Patch Release Note

Patch SB251-13 For SwitchBlade 4000 Series Switches and AT-9800 Series Switches

PCR: 03209 MODULE: ALARM**Level: 1**

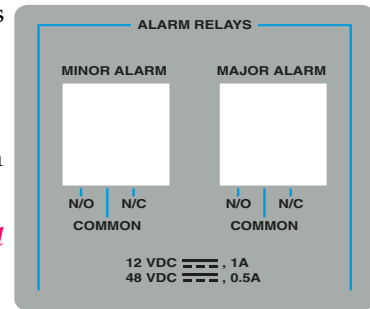
The action of the MAJOR and MINOR relays does not presently match the illustration located alongside their connections.

PCR: 03209 MODULE: ALARM Level: 1

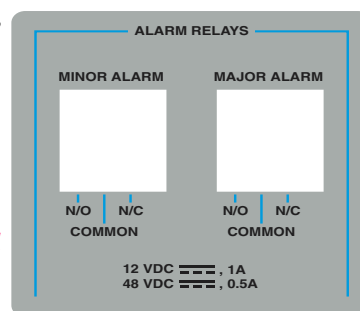
The action of the MAJOR and MINOR relays does not presently match the illustration located alongside their connections.
